SAGE CREEK COAL PROJECT

STAGE II SUBMISSION

Vancouver, B.C.
JUNE 1982

ENVIRONMENT CANADA REVIEW SUMMARY

Figure 1A shows the large volume of saturated rock within a working bench prior to dewatering.

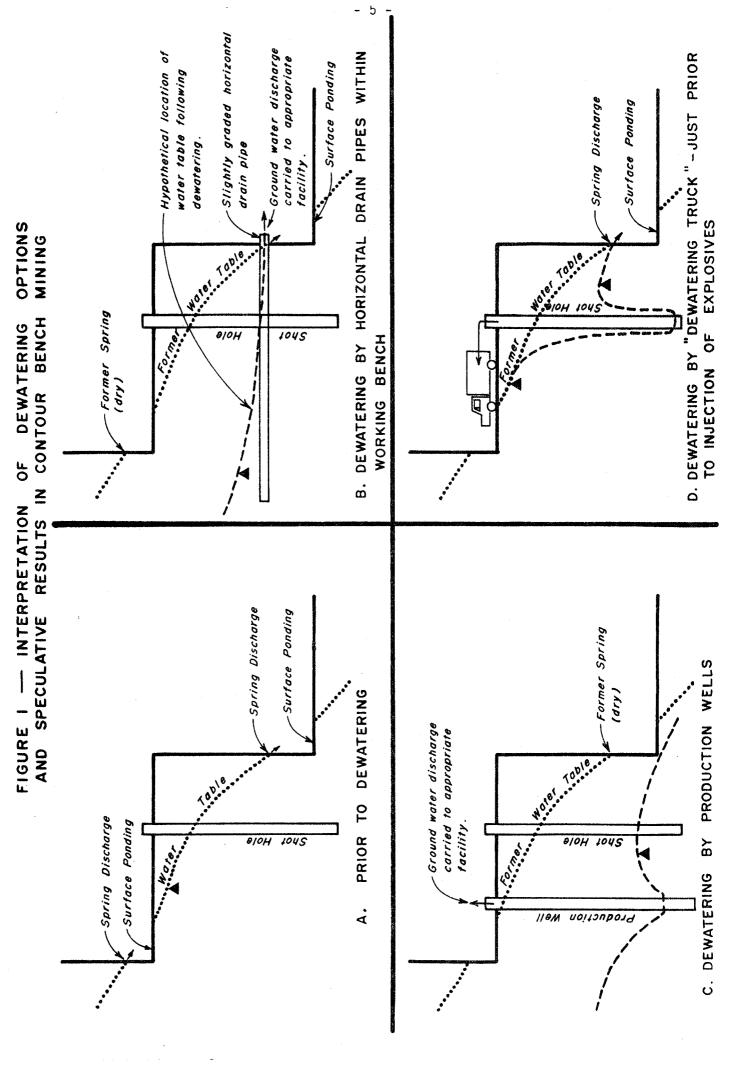
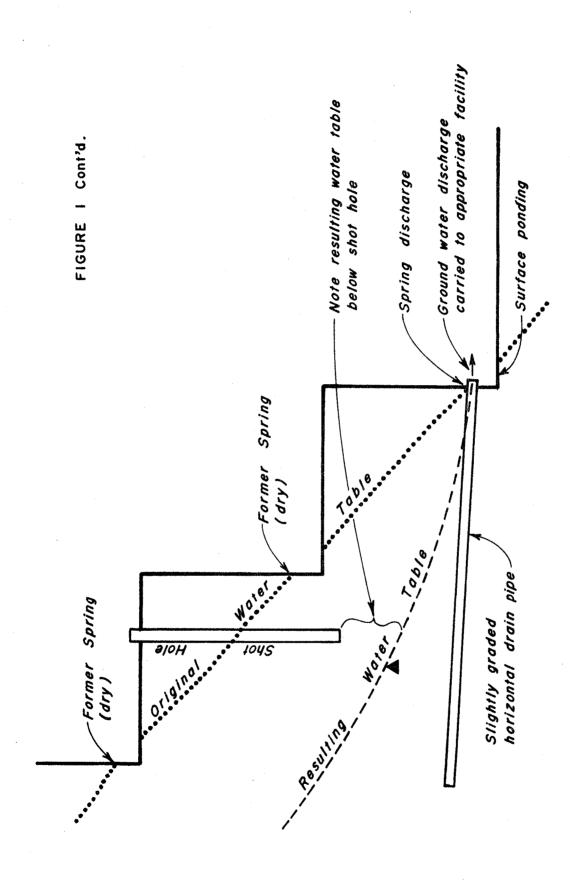
Figures 1B, 1C and 1E show hypothetical locations of induced water tables during dewatering by horizontal drain pipes and (vertical) production wells. Shapes of the induced water tables are controlled by depth of horizontal drain pipe or production well screen, time since dewatering commenced, permeabilities and degree of fracture interconnections,

Figure 1D shows the deep but narrow unsaturated cone of depression around a shot hole when drained by a dewatering truck. This unsaturated cone of depression 'rapidly' recharges when the truck's pump is shut off just prior to explosive injection. The resulting effects will be discussed shortly under potential nitrate contamination.

Once the hydrogeological setting is better understood then dewatering holes should be constructed and the vertical wells pumped. Horizontal wells should be placed on a slight grade to effectively remove drainage waters. Due to low fracture flow, considerable time will likely be required to drain much of the bedrock. Dewatering should commence well in advance of active mining.
